Subject: Response to Request for Additional Information regarding "Addendum 1 Revision 1 of WCAP-12488-A / WCAP-14204-A, 'Westinghouse Fuel Criteria Evaluation Process'," (Proprietary / Non-proprietary)

**Response to Request for Additional Information regarding
“Addendum 1 Revision 1 of WCAP-12488-A / WCAP-14204-A,
‘Westinghouse Fuel Criteria Evaluation Process’,” (Proprietary / Non-proprietary)**

**REQUEST FOR ADDITIONAL INFORMATION WCAP-12488-A [WCAP-14204-A],
"WESTINGHOUSE FUEL CRITERIA EVALUATION PROCESS"
SUPPLEMENT 1
PROJECT NO. 694**

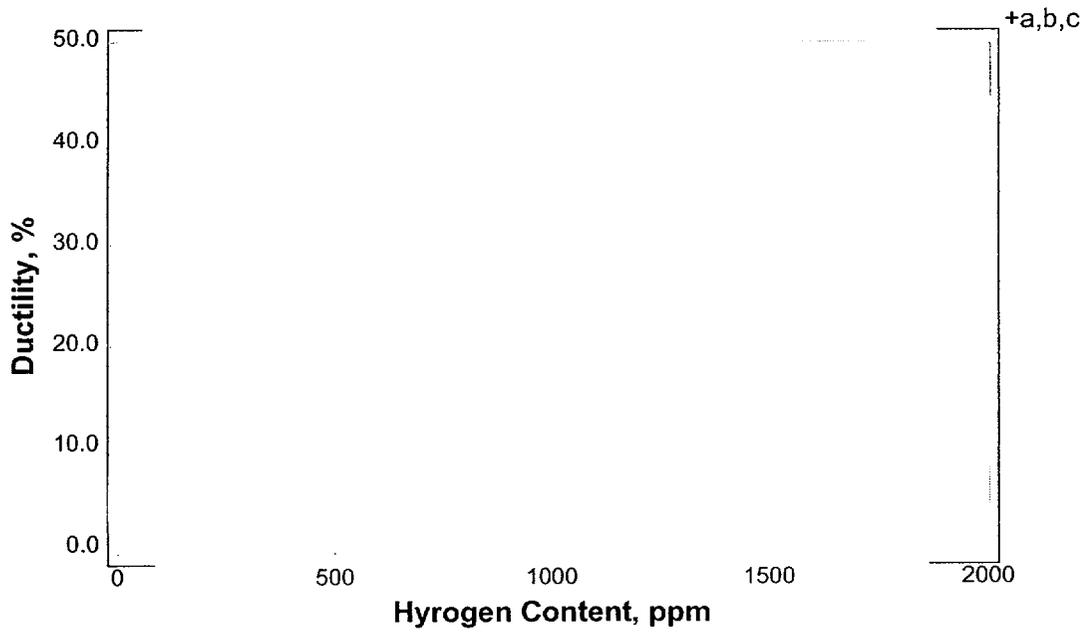
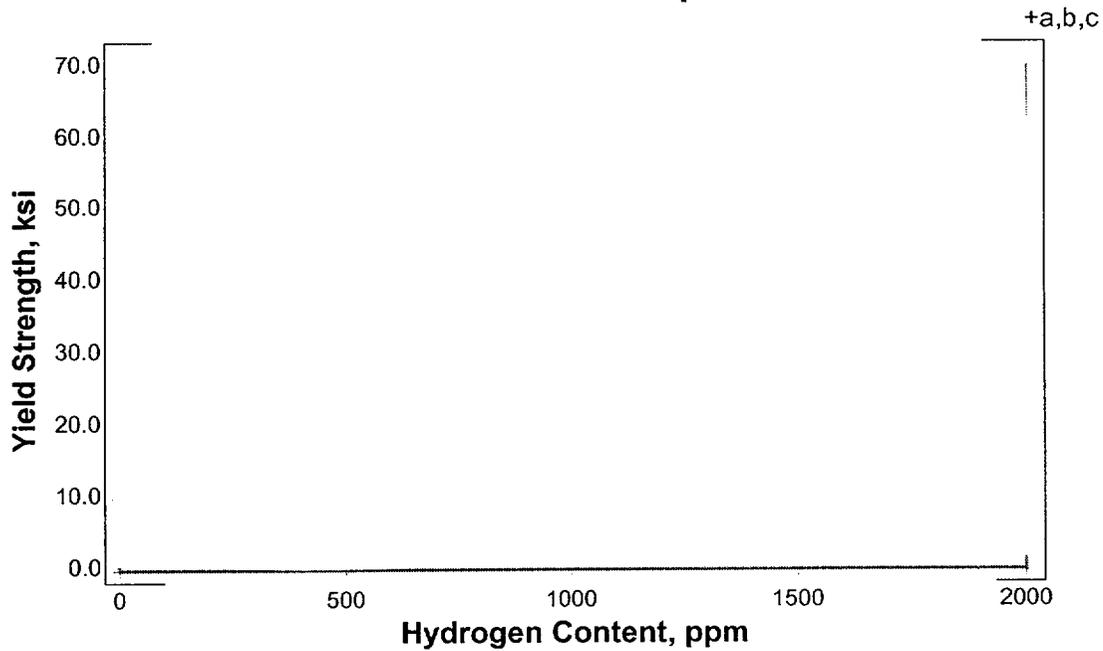
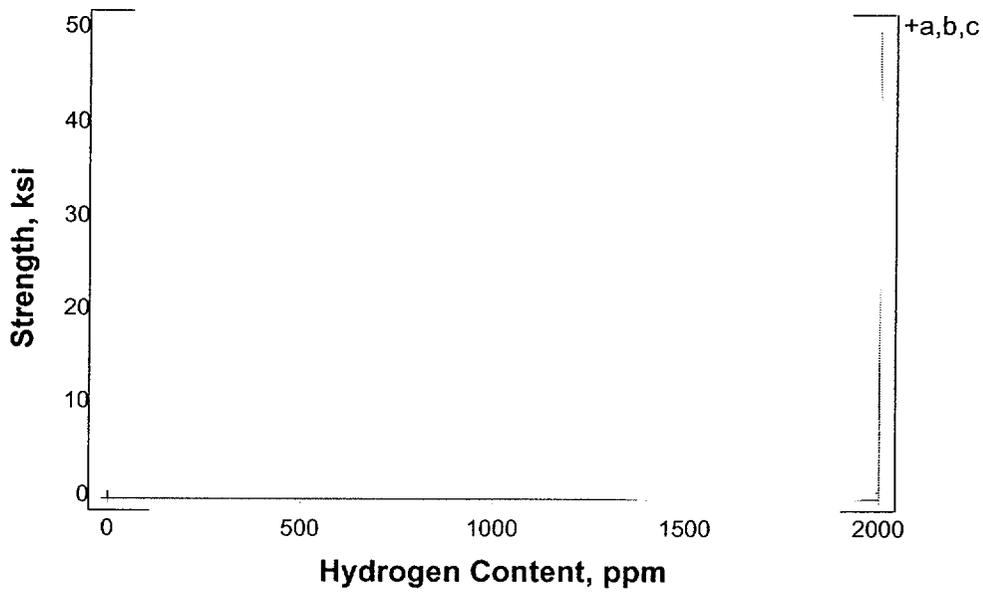
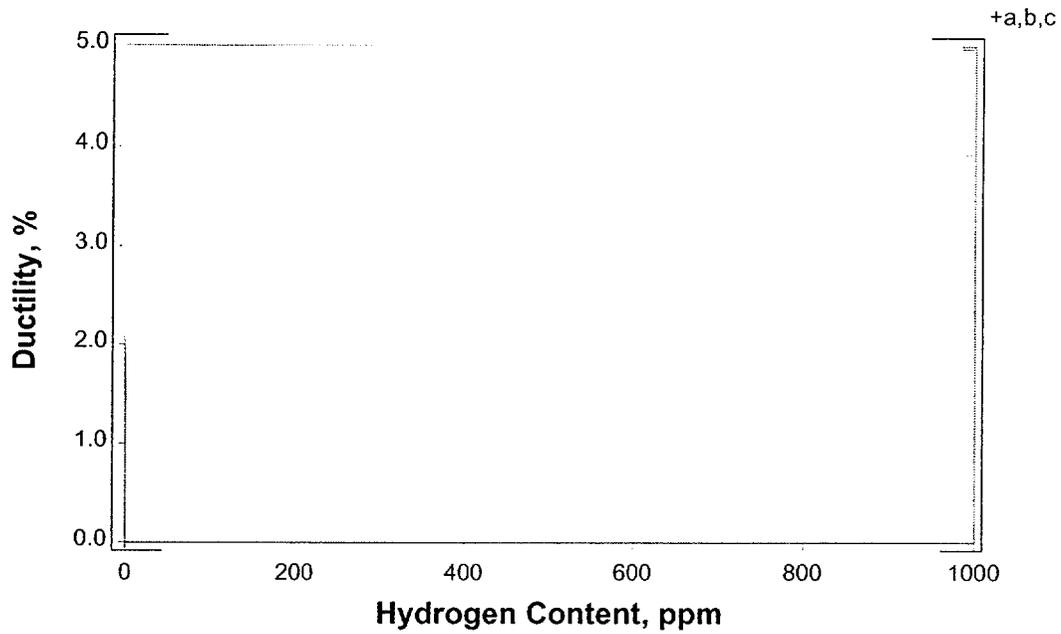
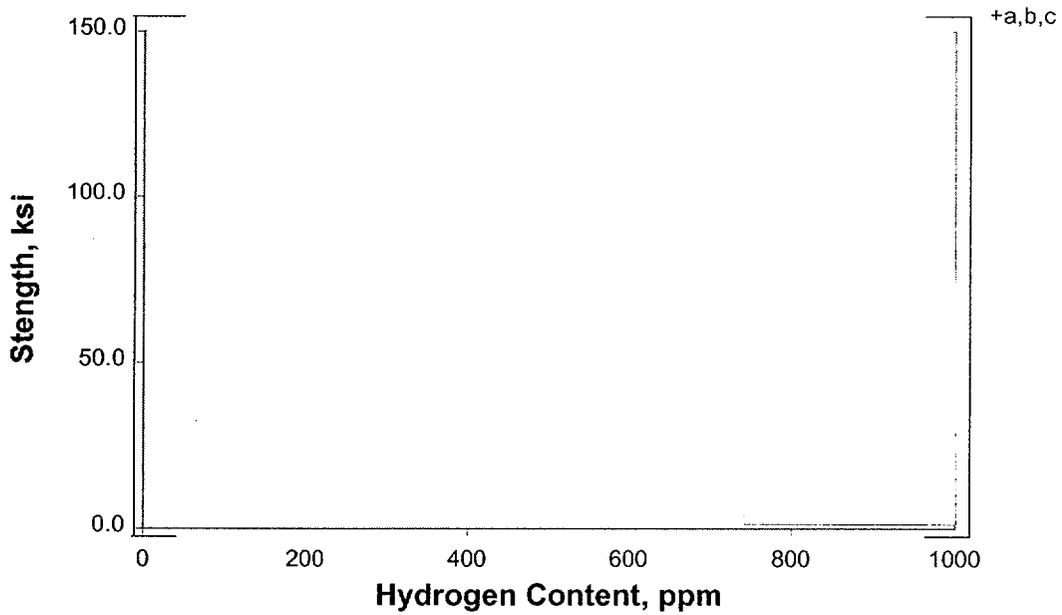
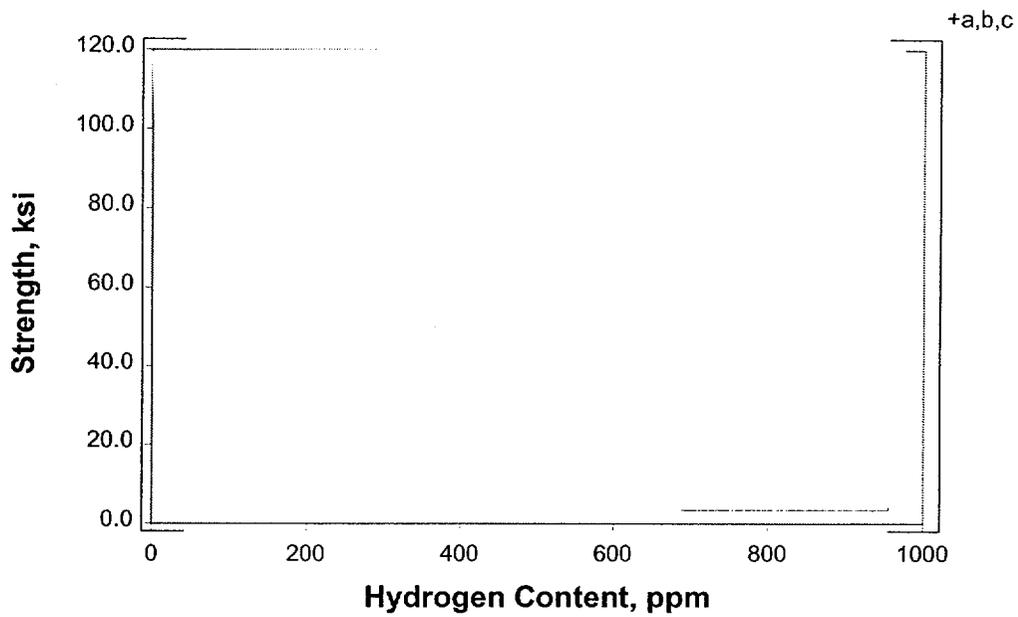
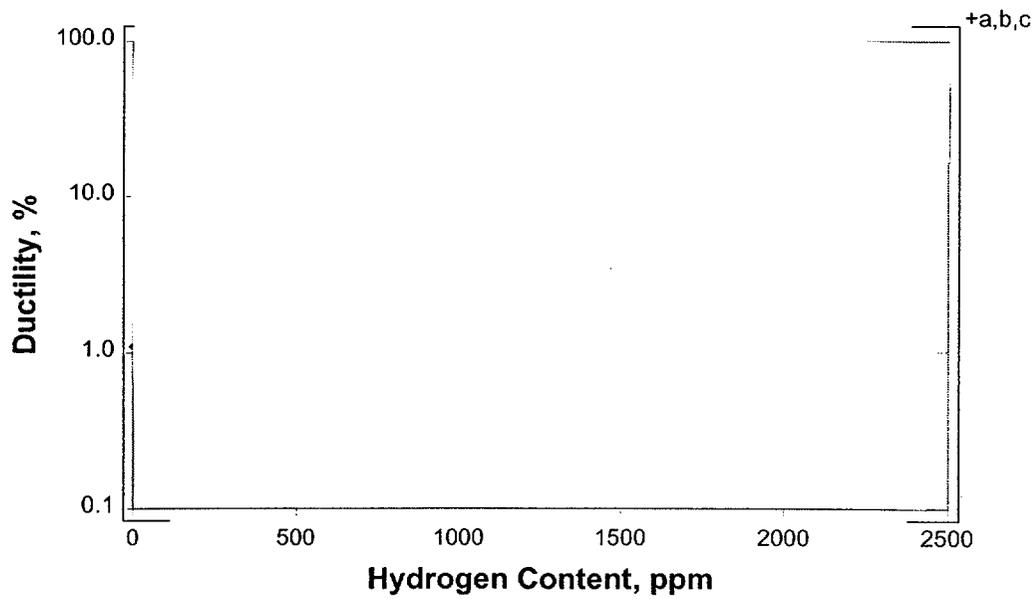
- b. 1st paragraph under "Effects of Hydrogen Content" subheading on page 2. "Westinghouse has conducted programs..." Reference cites are needed for the discussion under this heading and the figures that are provided.

Response 2b: Reference 12 has been added. Refer to the updated Addendum 1 Revision 1 with revision bars noting the changes (copy attached).
